LHQ structure

Items for discussion

Collaboration Meeting 18

May 7th to 9th 2012, FNAL

LHQ (120 mm – 15 mm)

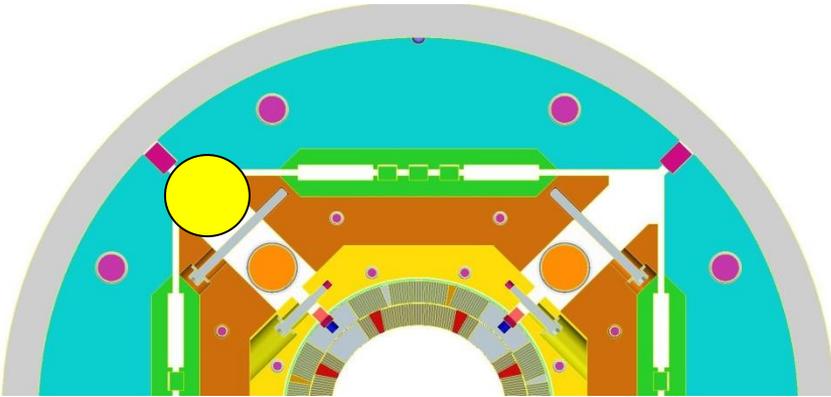
- Preserve space for the rods
- Preserve gap keys
- Preserve magnet OD => important to allow testing at FNAL test facility

MQXF (140 mm – 17 mm)

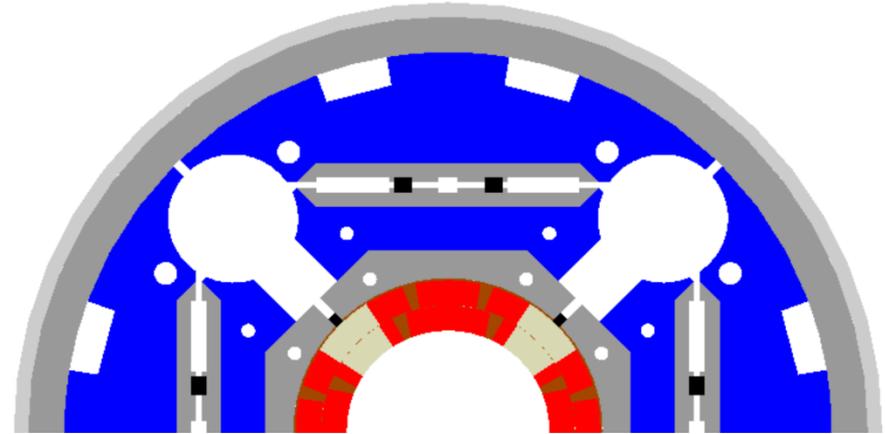
- Does NOT preserve space for the rods
- Preserve gap keys
- Increases magnet OD

=> LHQ should provide holes demonstrating the principle but will not match the LHC requirements (?)

HQ01d – full length G10 key

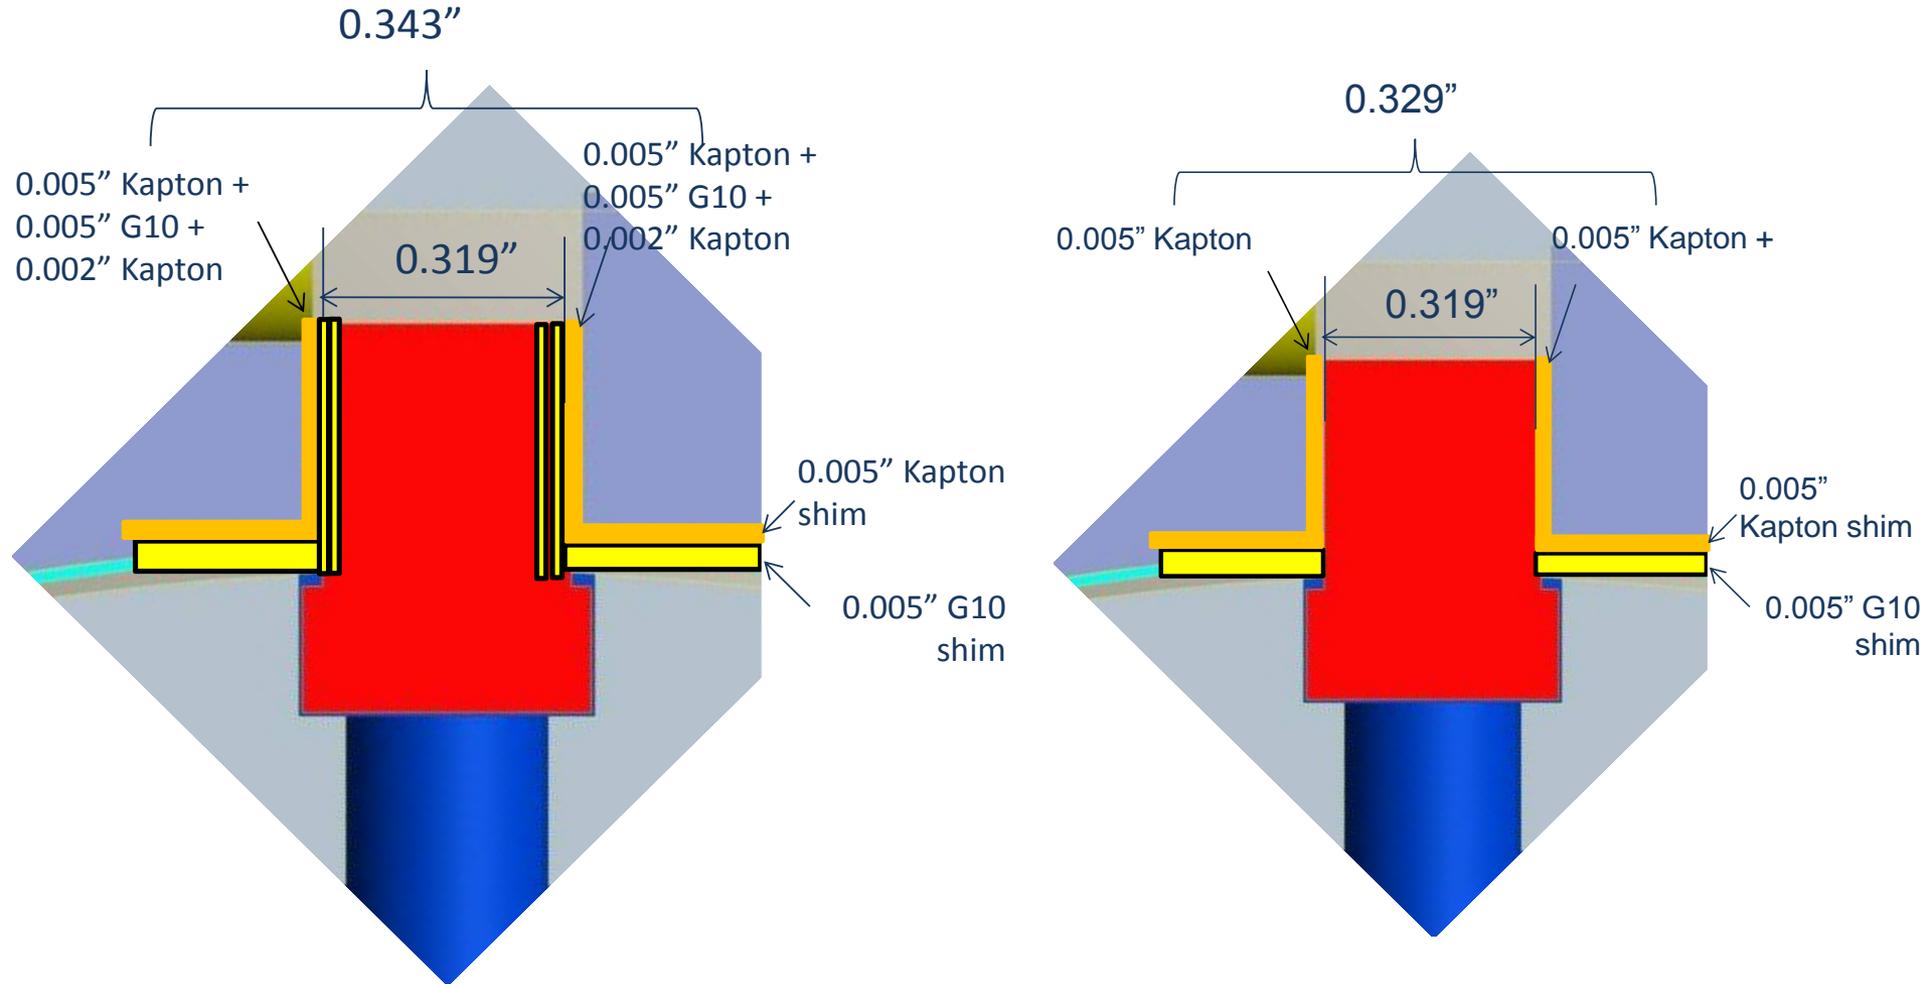
- Holes in the pole
 - Require key segmentation or holes in the key
 - Possibly affecting size of each coil's outer layer keyway width and depth (impacting pole segment profile, alignment key design & collar profile)
- Impact on Ground plane insulation

LHQ cooling Holes and Ground Insulation

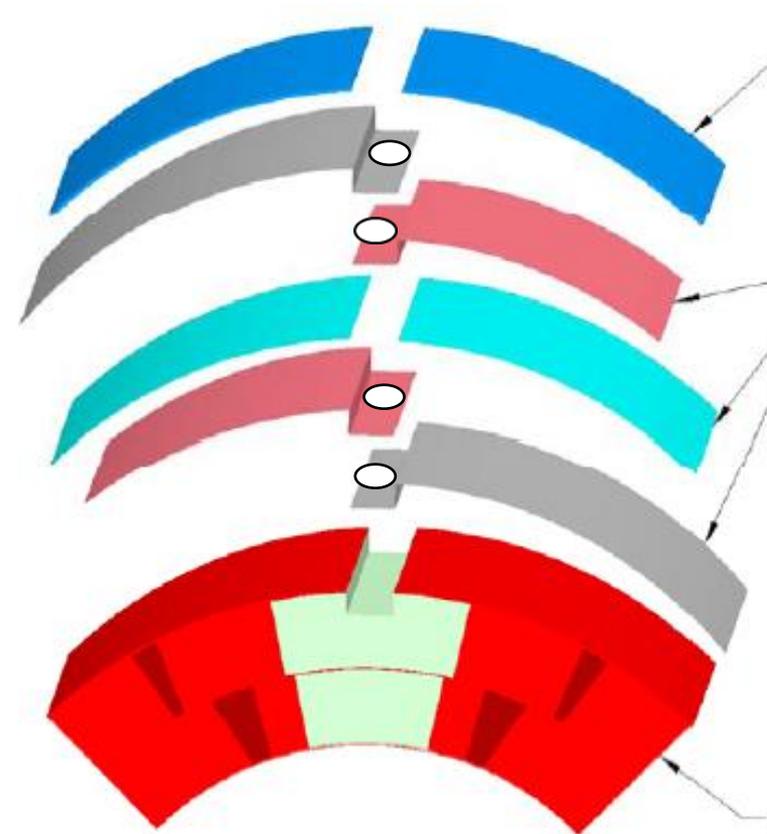
- Possible solutions:
 - Segmented key with hollowed insulating spacers around the cooling holes
 - Some insulation on collars close to the holes?
 - Better ideas ???
